January 2024 | Danfoss Climate Solutions for cooling

Cool Update

CTM 6 Multi Ejector – Removal of the DST Pressure Transmitter

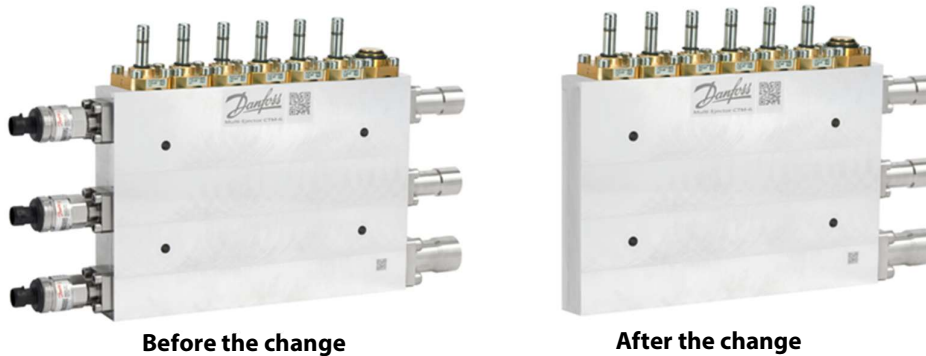
DST P310 pressure transmitters will be removed from CTM 6 Multi Ejectors design.

Danfoss is continuously looking to improve the performance of our products. Recent feedback from our customers show that the pre-installed pressure sensors are almost never used. Therefore, to improve quality and lower our costs, we are removing the pressure sensors from the design.

Pressure transmitter will no longer be part of CTM 6 Multi Ejector design.

An important advantage is less environmental impact – removing difficult to recycle electronic devices and decreasing the weight of the whole product (12 steel screws and sensor mounting plate removed).

Below pictures illustrate the change:
